Trust Knitwear Industries Ltd.(Extended)

Bhabanipur, Gazipur Sadar, Gazipur.

4 December 2023

Observation-1: Inconsistencies in the design report.

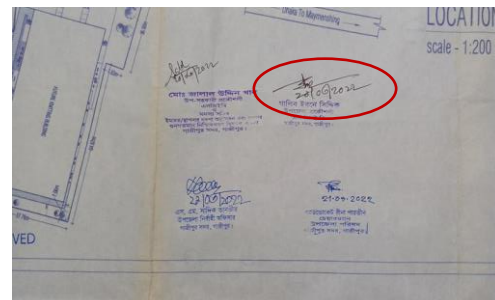
Description: The factory got approval from LGED (local authority) on March 2022, but the analysis was done as per BNBC 2006. Building engineer is required to update the design documents as per actual site conditions complying with BNBC 2020.

Also, no information of the foundation was found provided in the as-built drawings. Building engineer is required to incorporate foundation information with adequacy as part of Detailed Engineering Assessment (DEA).
